> Product Change Notification (PCN)

Product group:	MINISKIIP II	Rev.:	0
No.:	PN20-017	Introduction of an additional supplier and alternative material for standard pressure lids	28 Feb 2020

Subject of change: Additional supplier and alternative material for standard pressure lids

Lid size 2

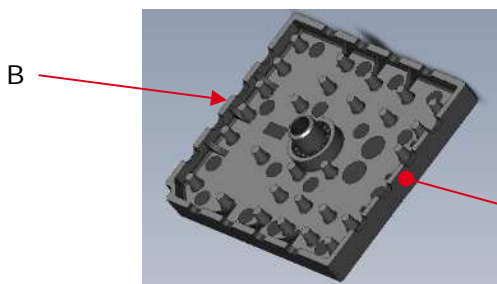
Lid size 0,1,2,3

„R” or „T” marking for different materials

The injection point moves from point “A” to point “B”.
